MYO FINAL MONITORING REPORT

Odell's House Mitigation Project

RE: WLS Responses to NCDEQ DMS Review Comments for Task 6 Submittal, Draft Baseline Monitoring Report for the Odell's House Mitigation Project, DMS Full-Delivery Project ID #100041, Contract #7420, Neuse River Basin, Cataloging Unit 03020201, Johnston County, NC

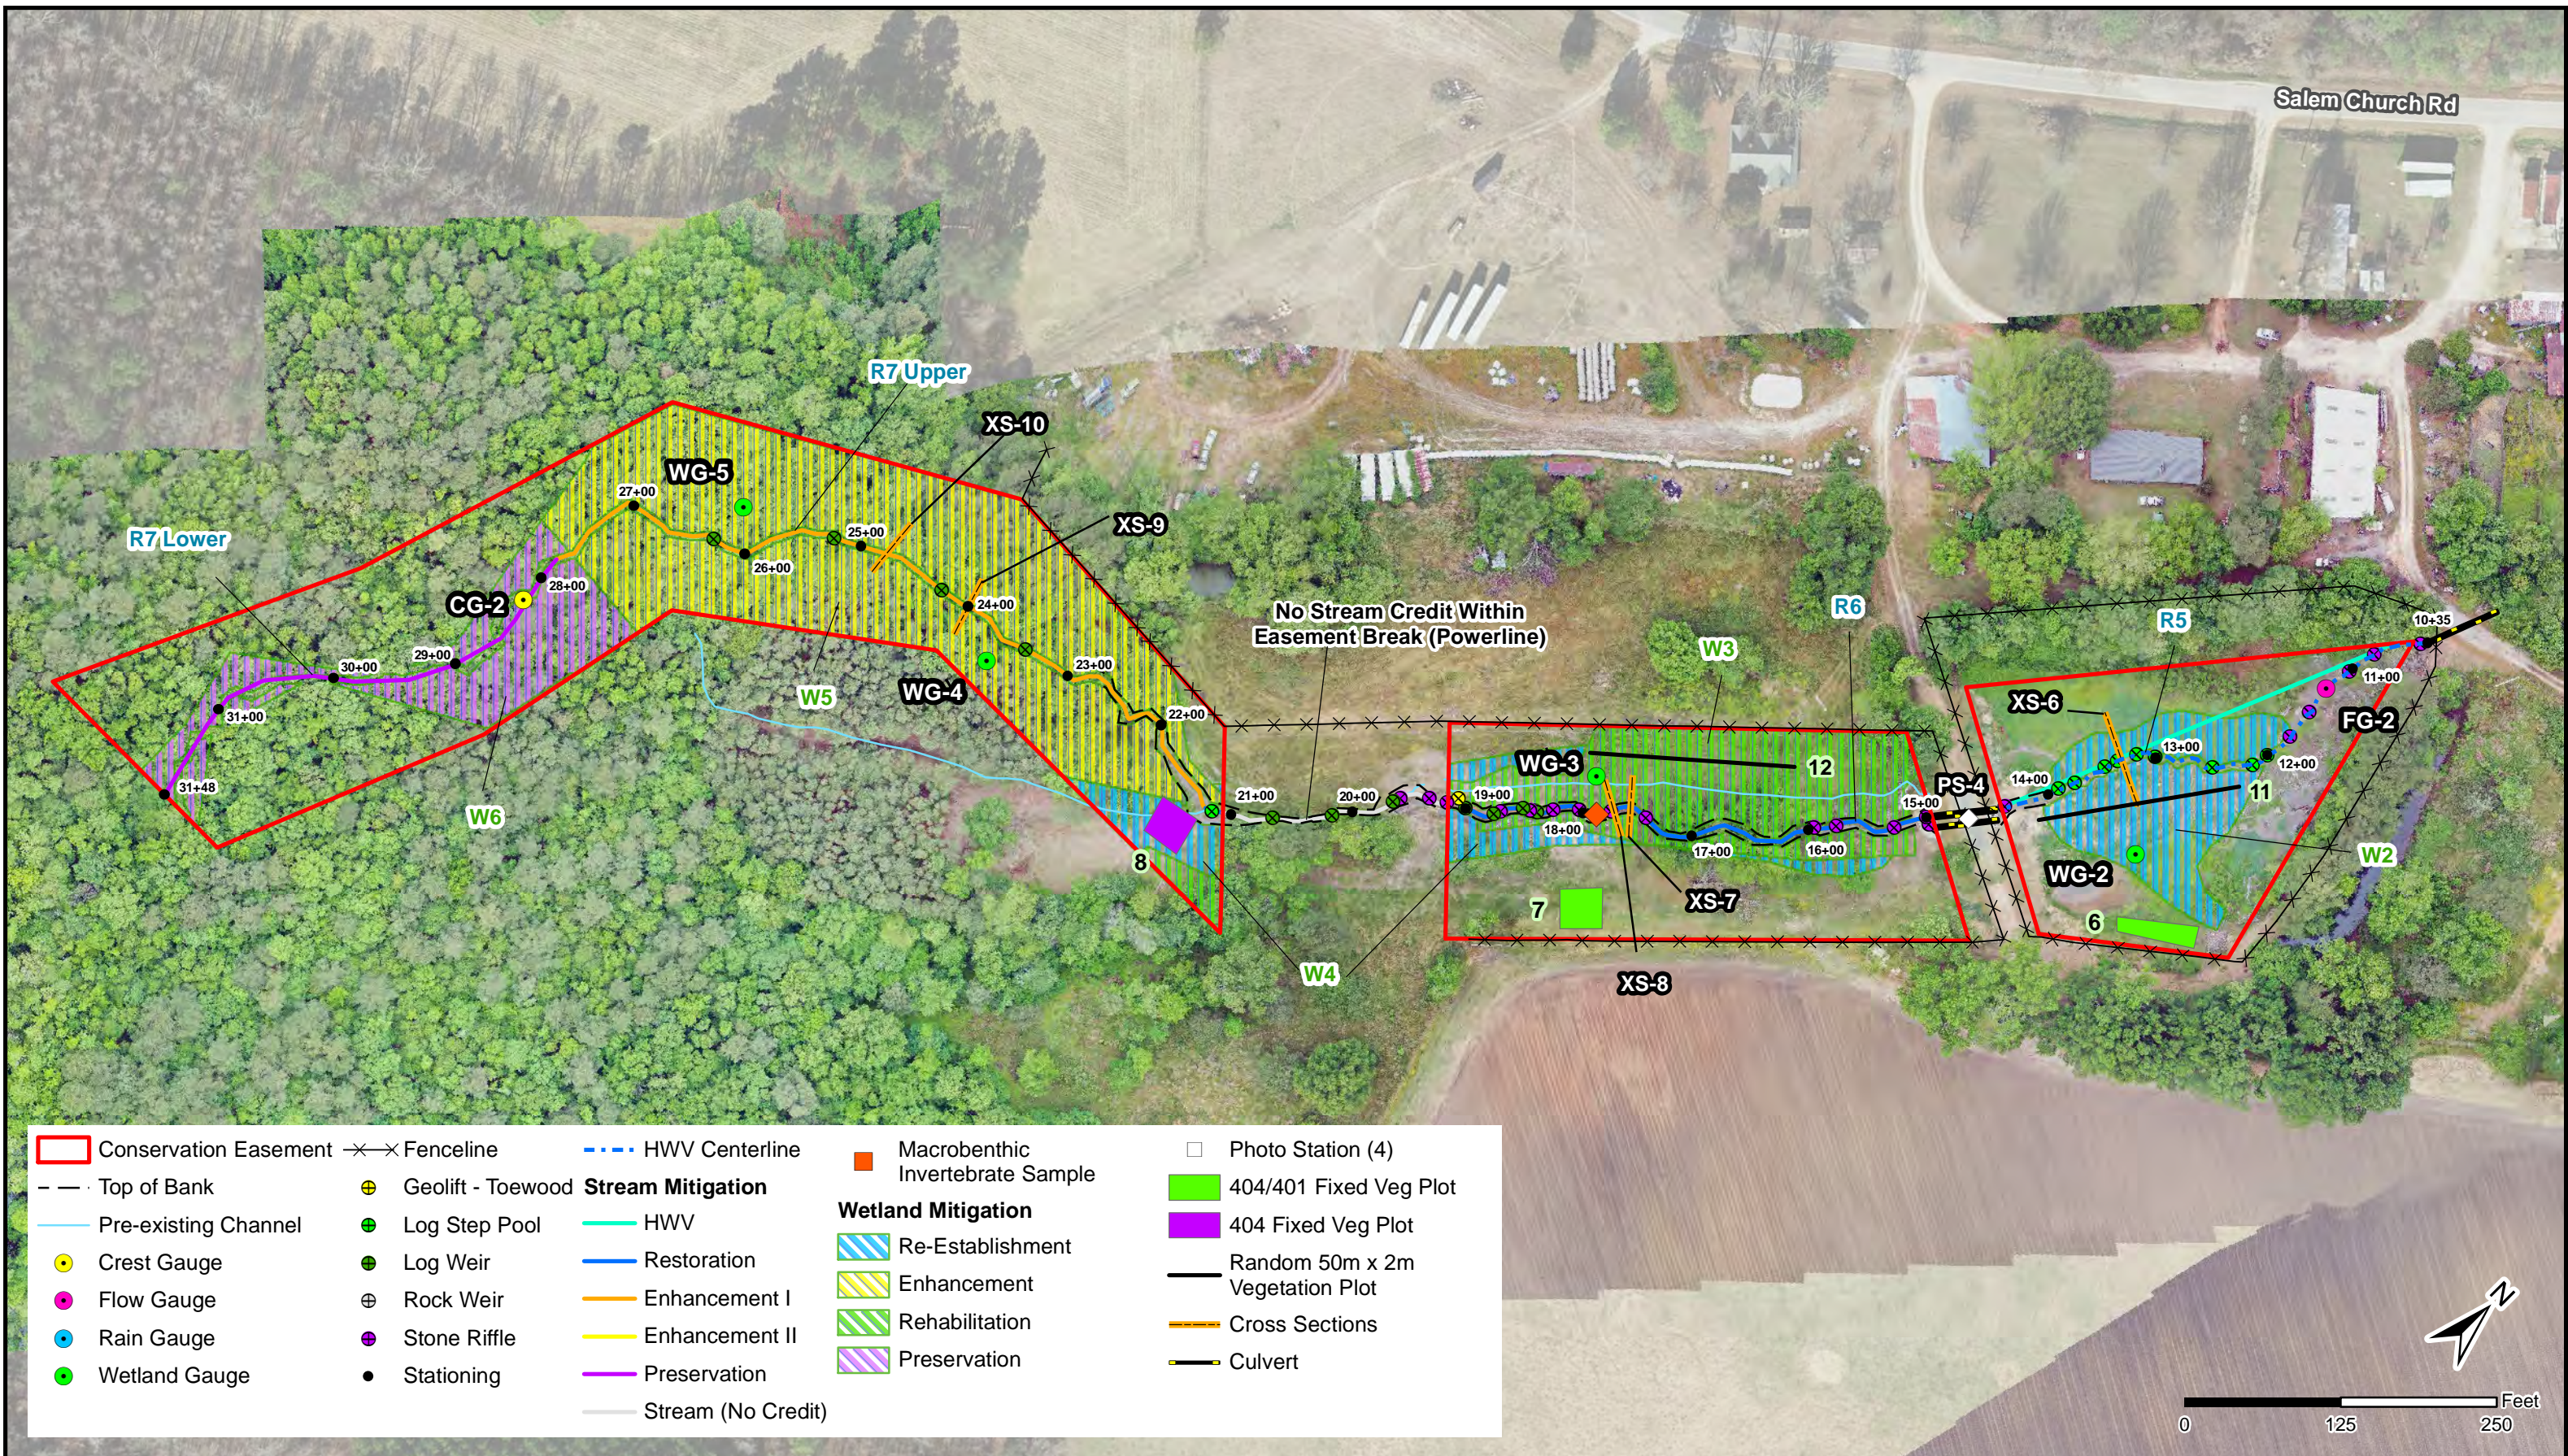
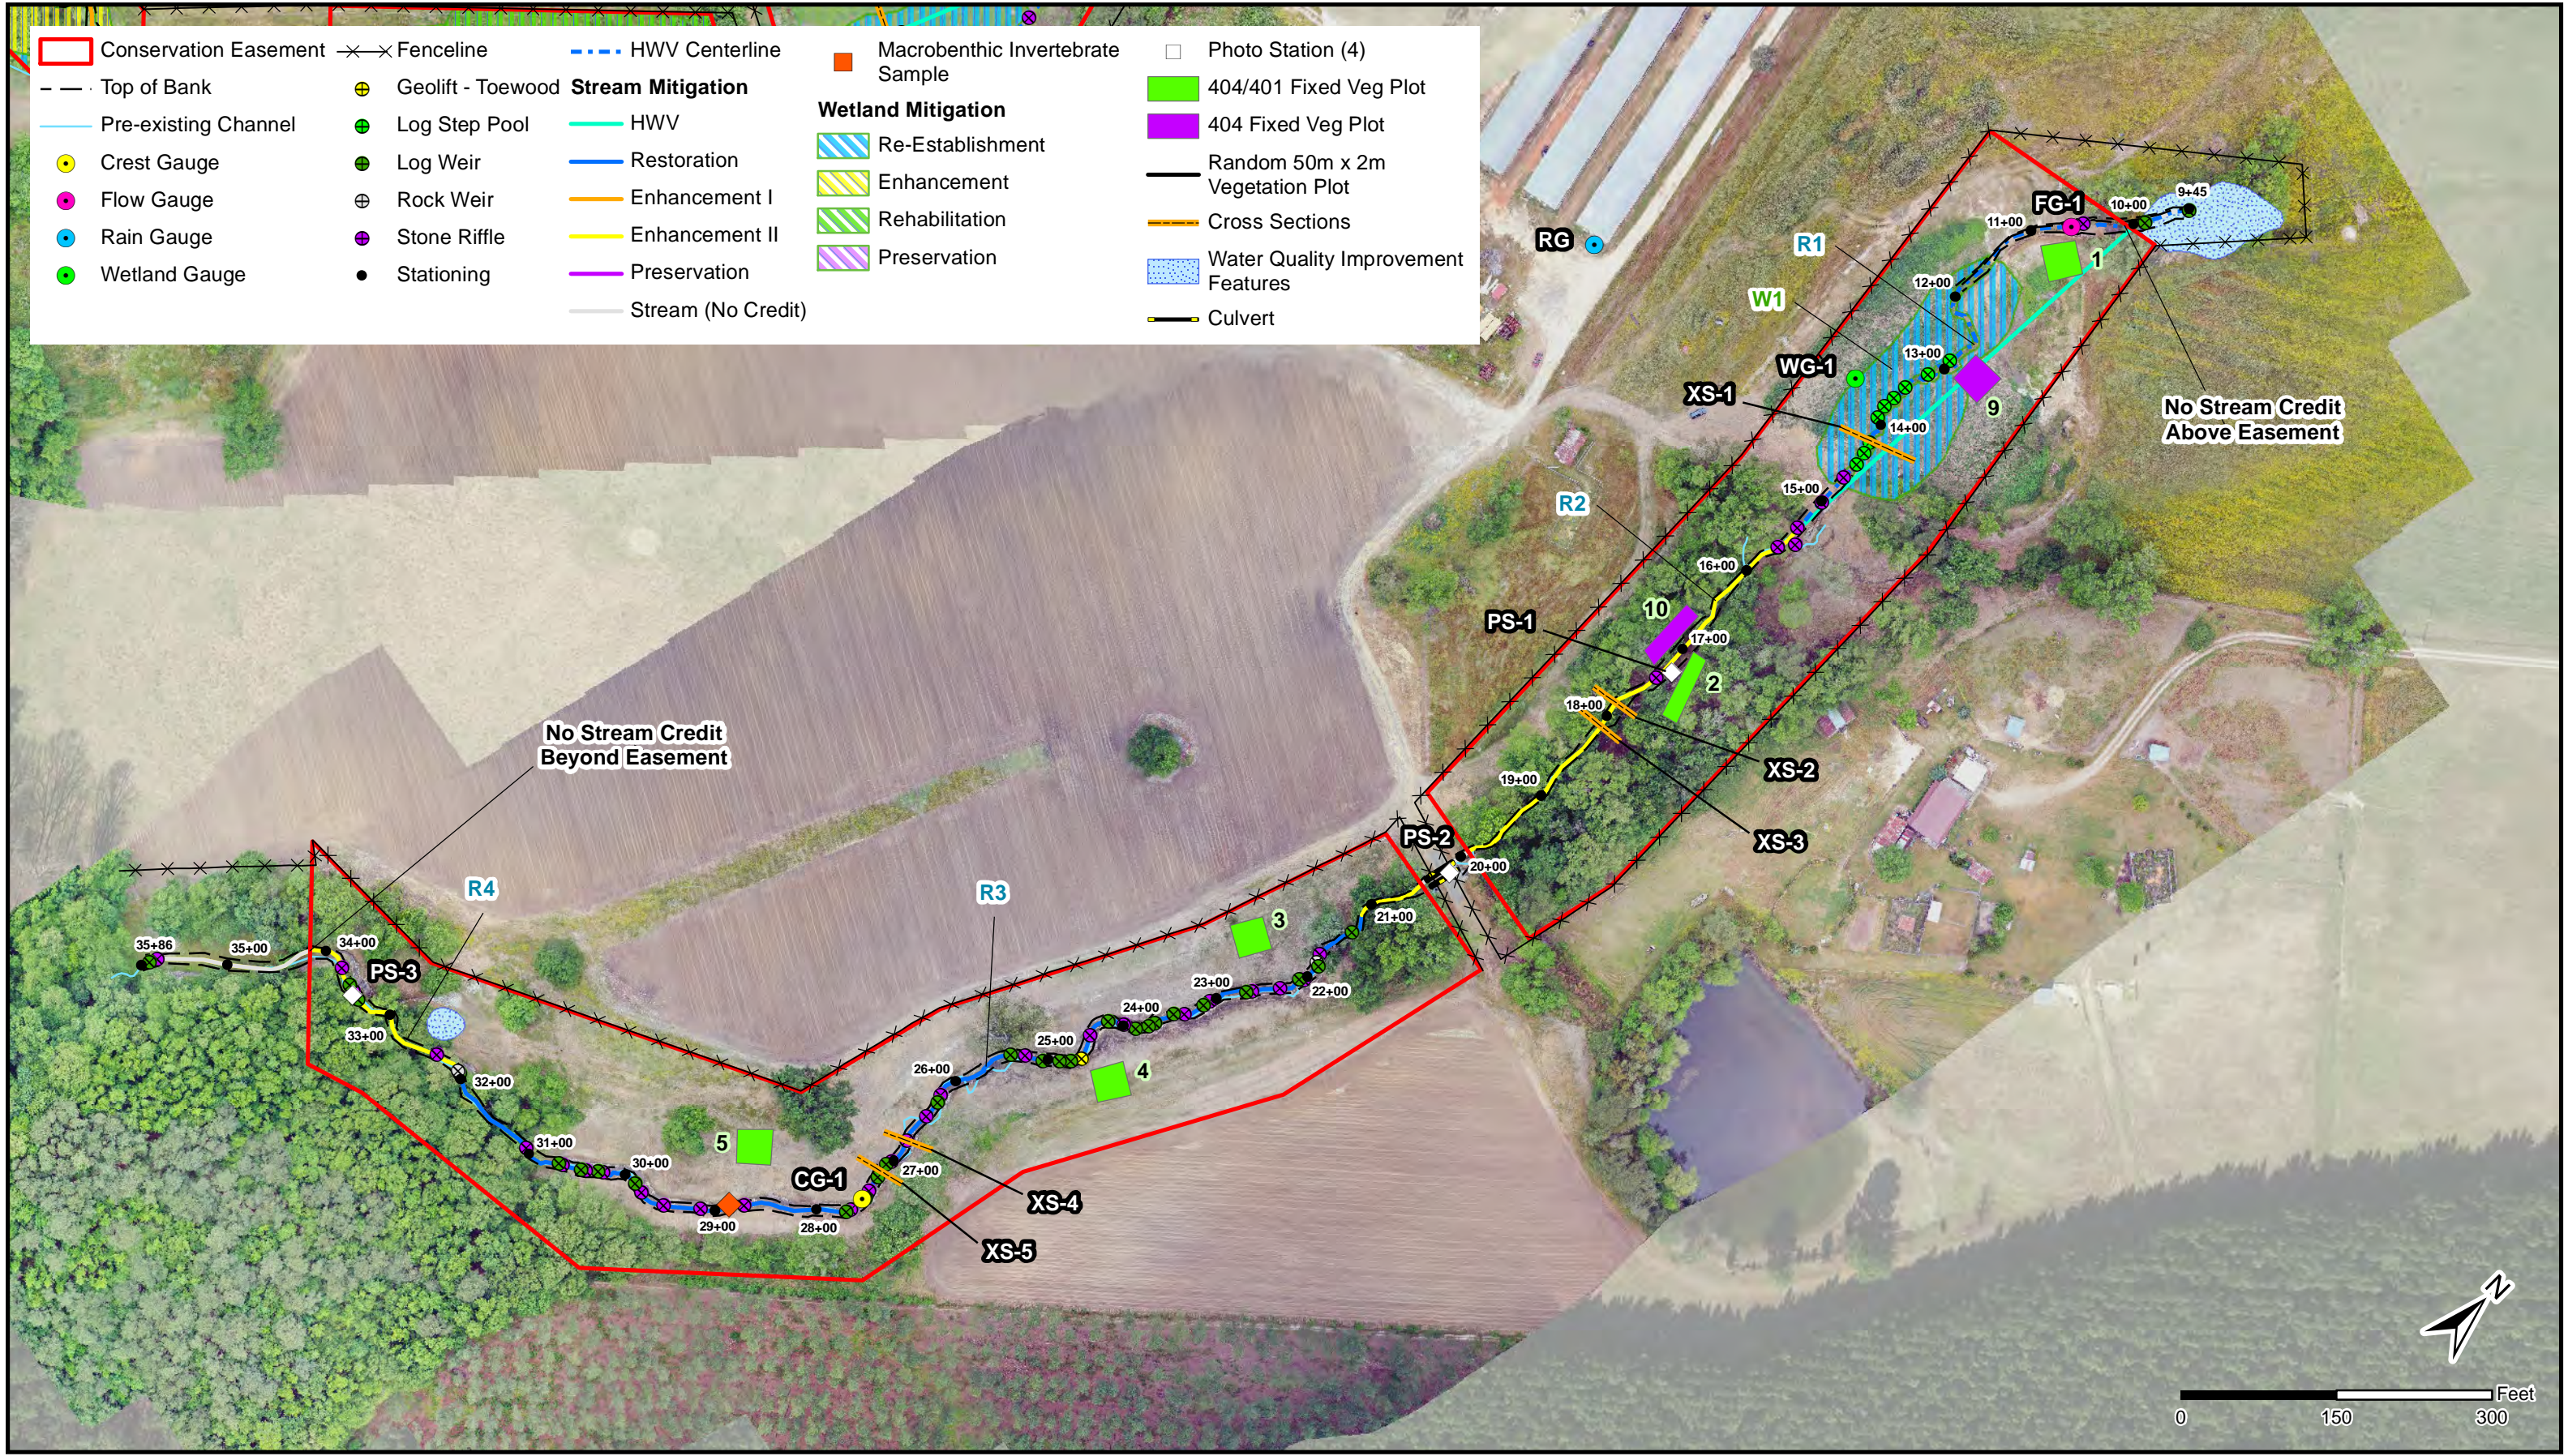
- **Please label the wetland areas on the detailed pages of the CCPV (1a and 1b).** Response: The wetland areas have been labeled on Figures 1a and 1b.
